**American River Flood Control District
Central Valley Flood Protection Board Permit Application
New Power Pole and Underground Conductors near Lathrop Way (SMUD)
Staff Report**

**APPLICATION FOR A CENTRAL VALLEY FLOOD PROTECTION BOARD
ENCROACHMENT PERMIT**

Contact Person:	Yujean Kim	Job Name:	EVERGREEN/ROYAL OAKS 1203 EXTENSION Commerce Dr. s/o Lathrop Wy.
Job Number:	30145759	Contact Number:	916-732-5442
Type of Drawing:	Permit Sketch

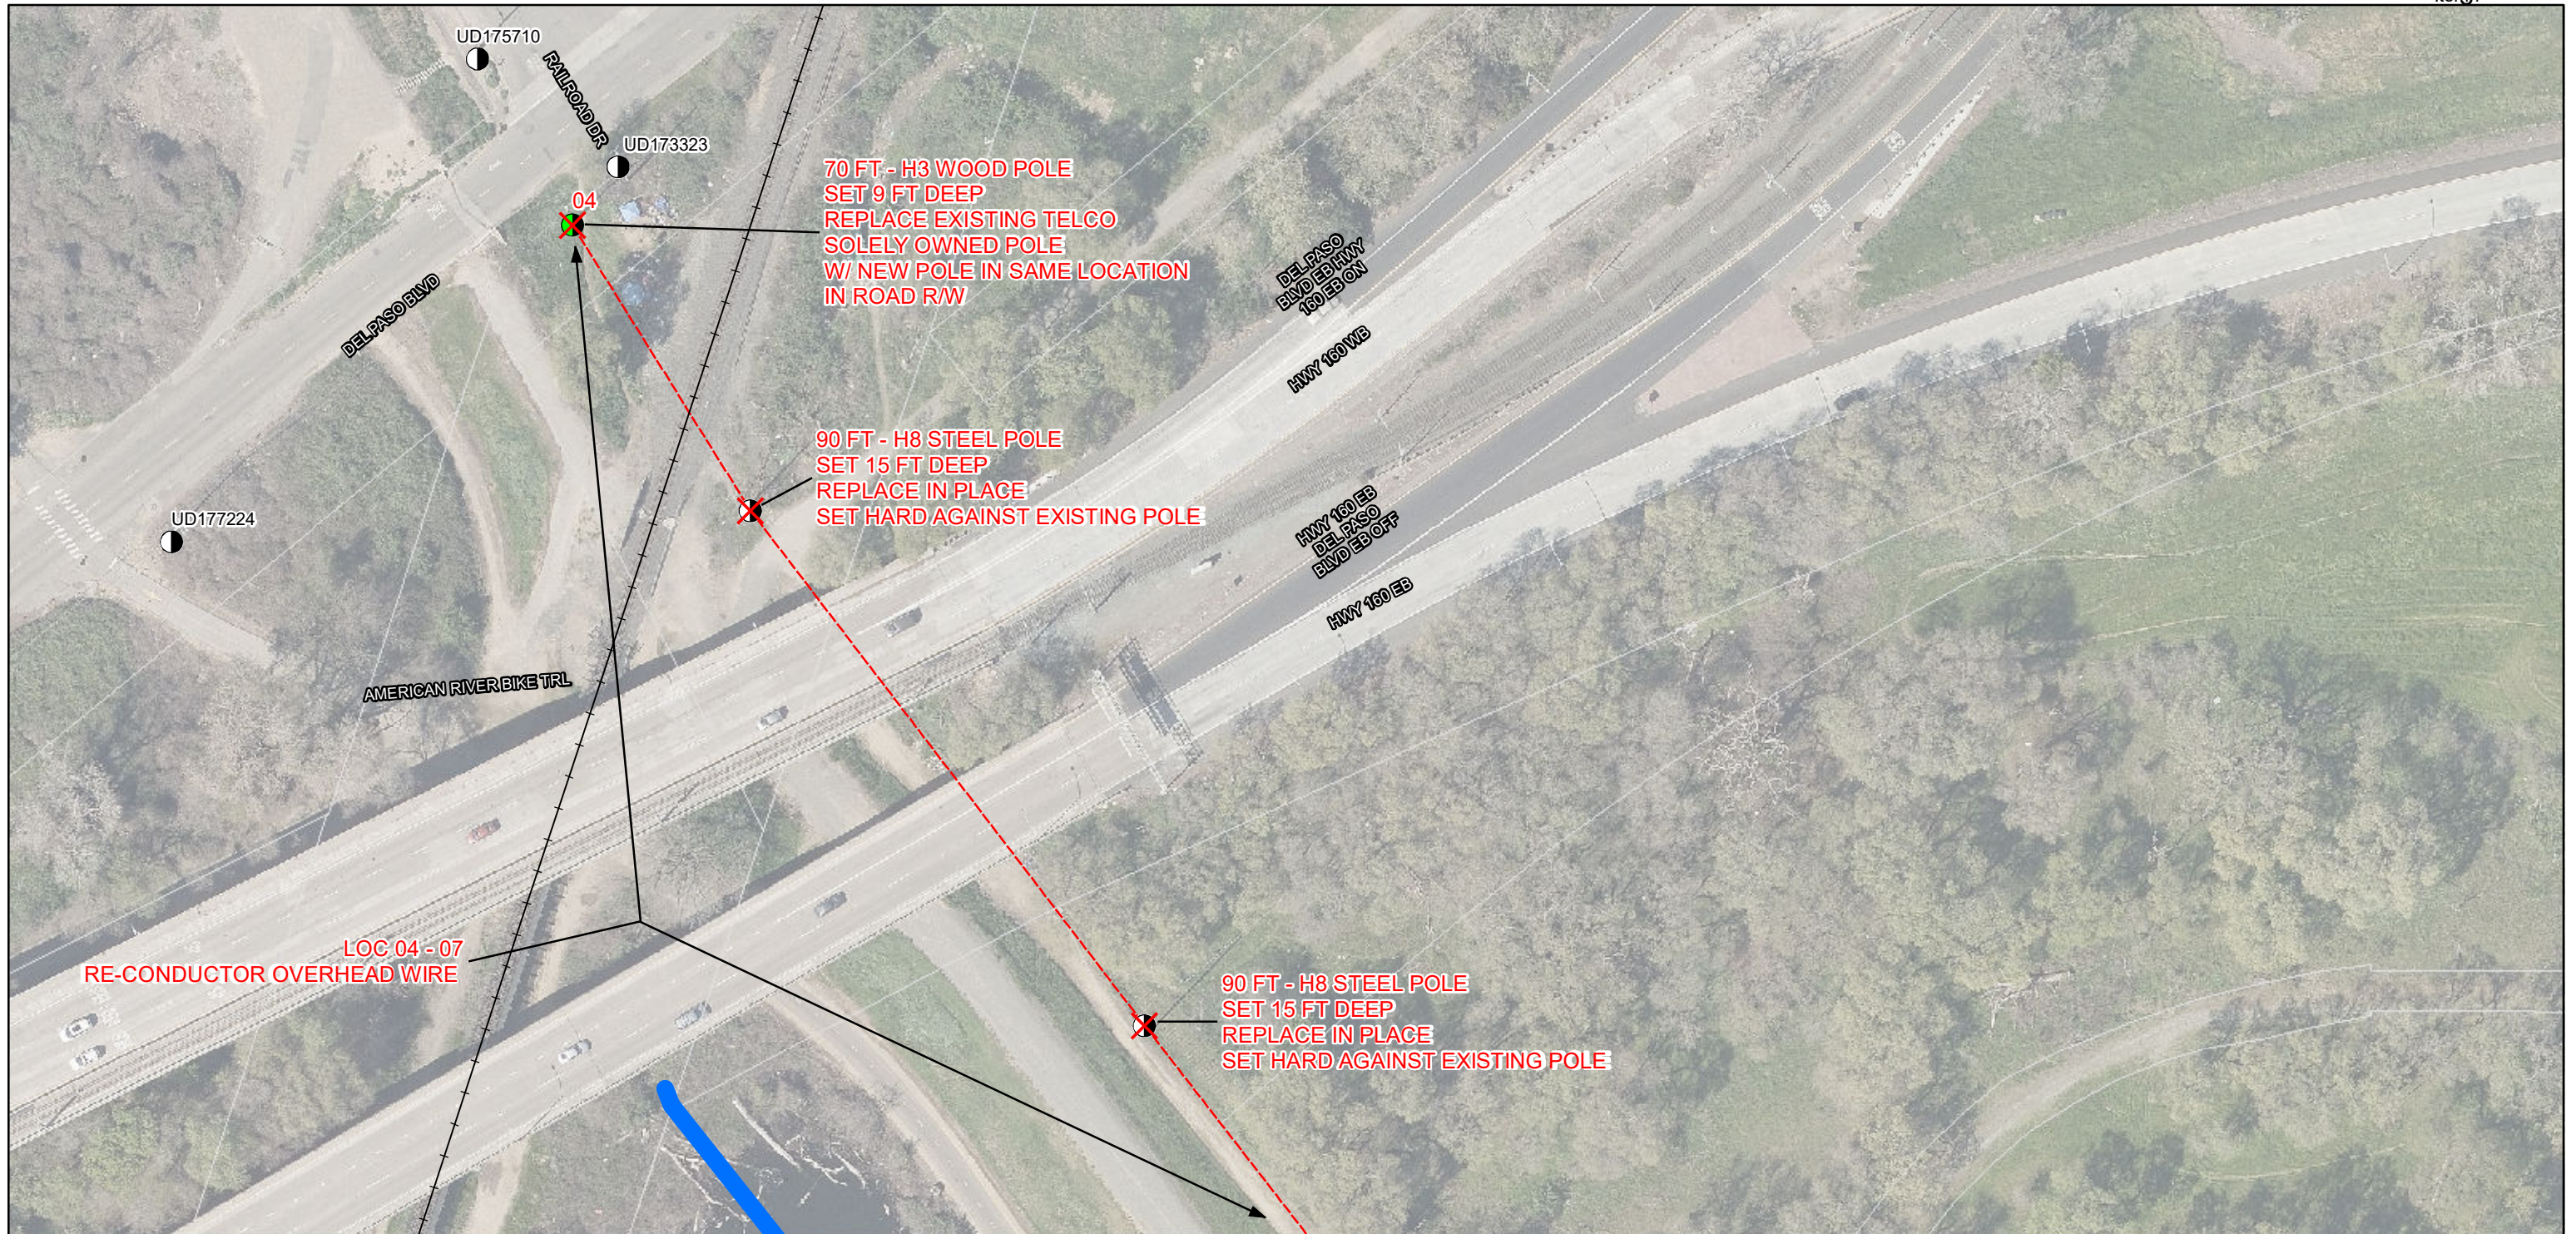
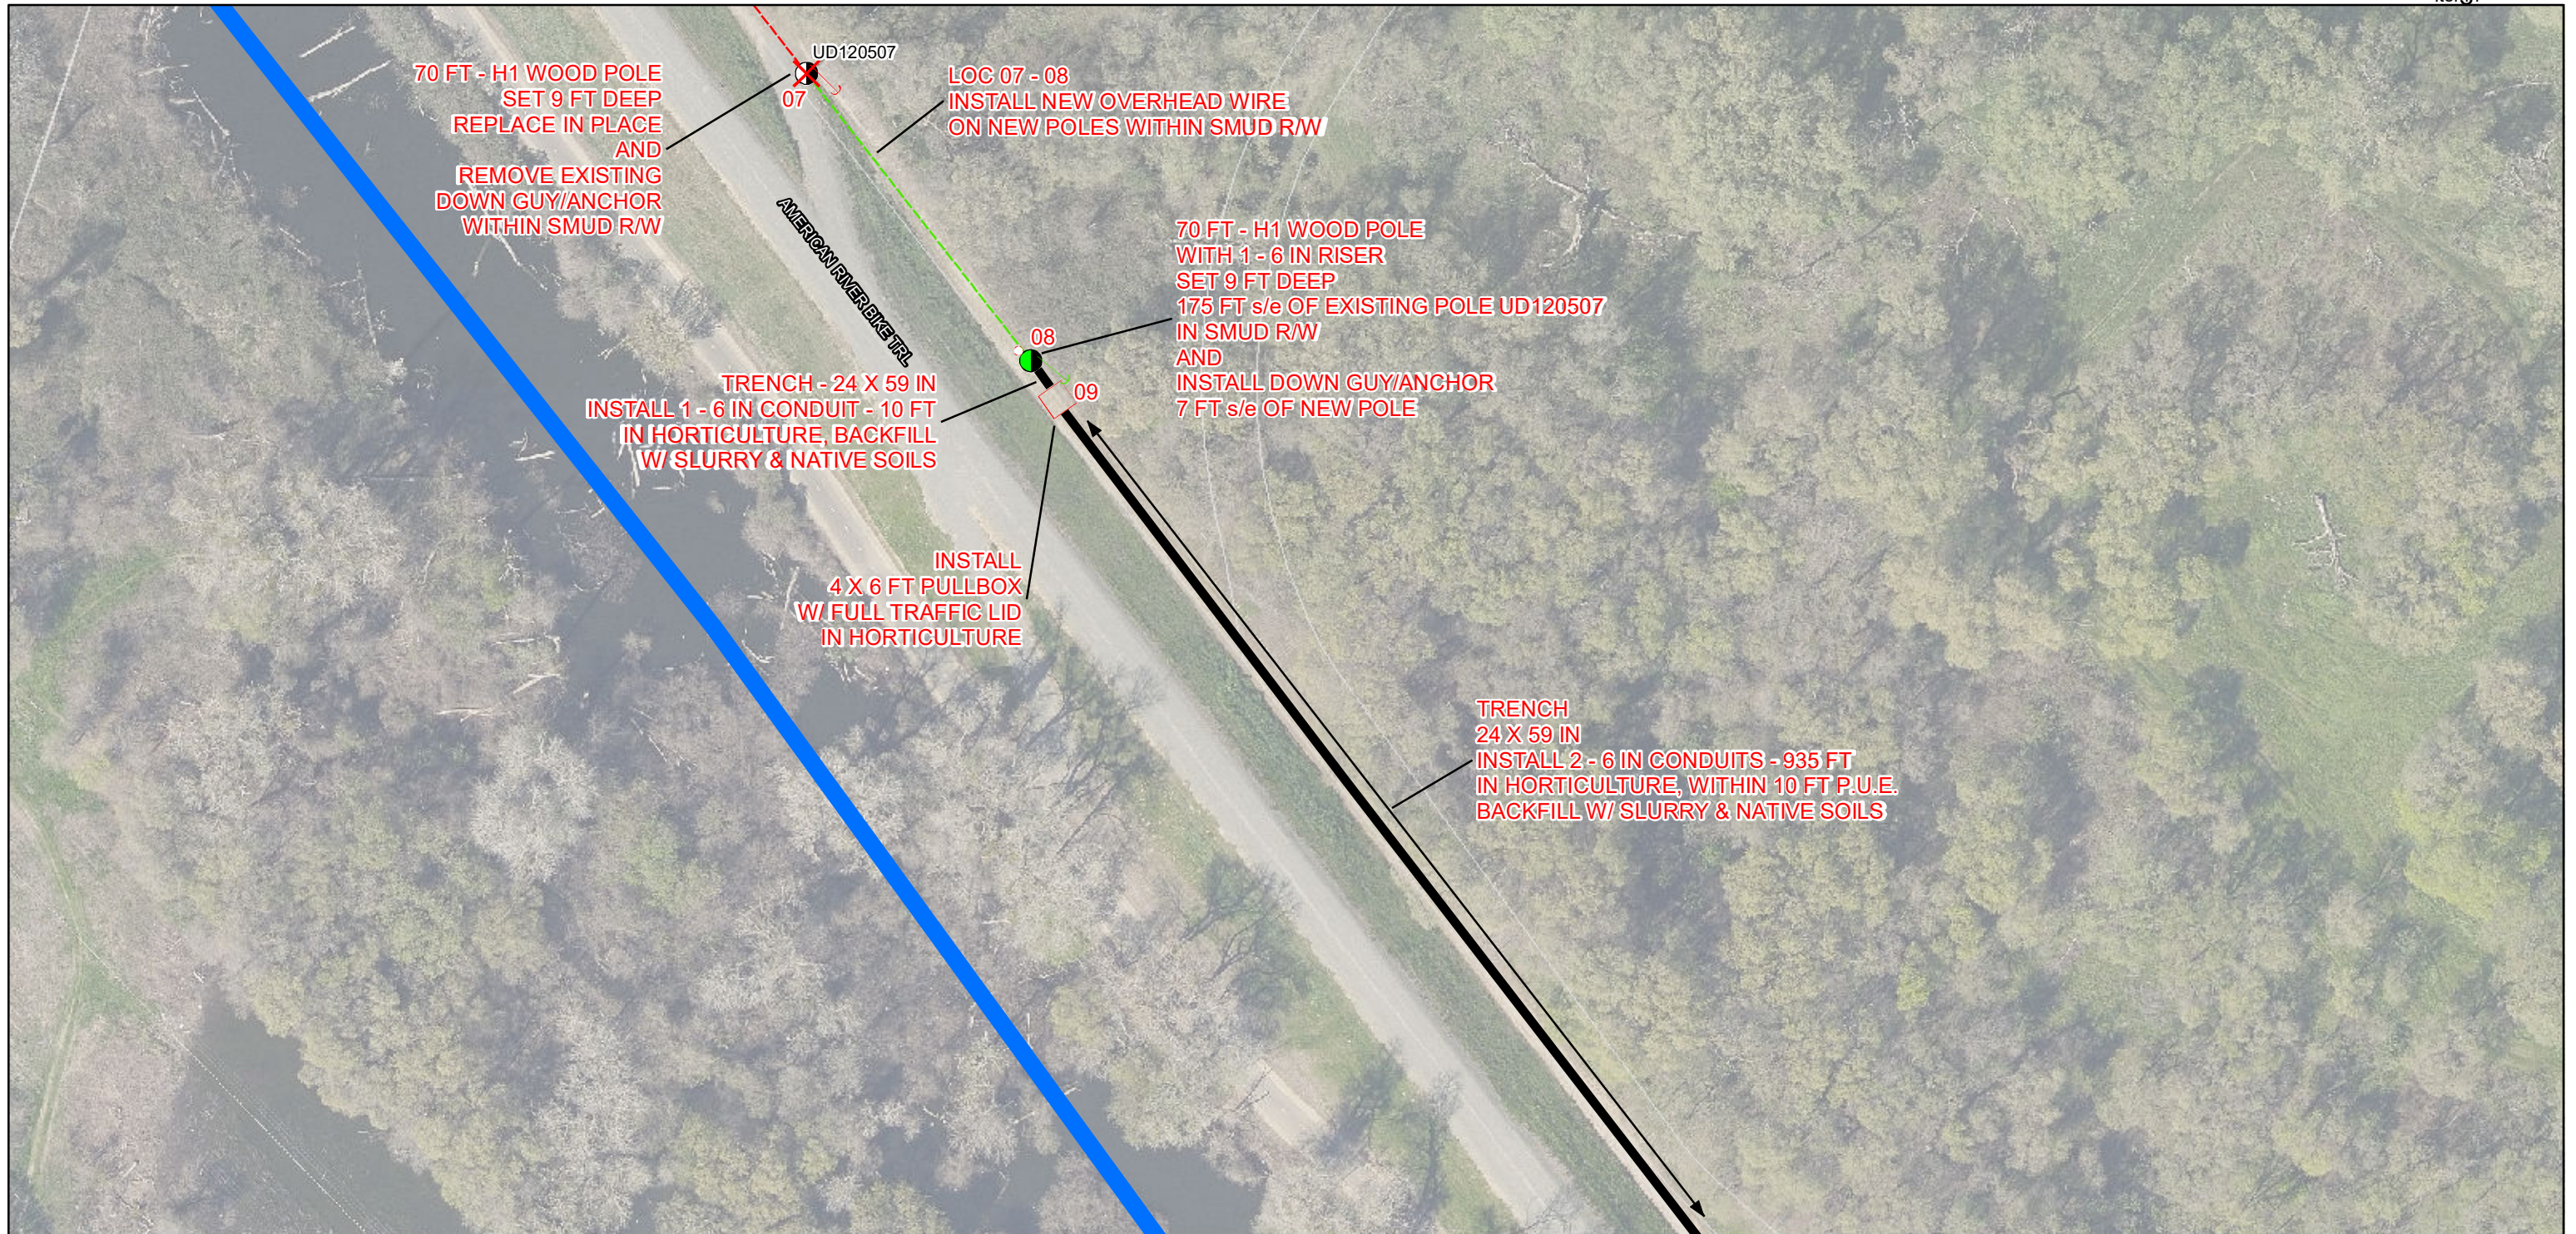
The existing power pole replacements will remain in the same location as they are currently and will not create new impacts to District operations.

The new power pole will also require installation of a guy wire. SMUD has confirmed that the guy wire will be aligned parallel to the levee so that it will not project into the levee slope or toe road. The impacts from this work will be small and the District will work around the proposed pole and guy wire.

The underground conductor will be installed by trenching and the trench will be backfilled per Title 23 standards. The District will need to avoid any digging near the toe of the levee upon installation of this feature. Otherwise, impacts from this proposed feature are negligible.

The General Manager recommends that the Board of Trustees endorse the permit application from SMUD.
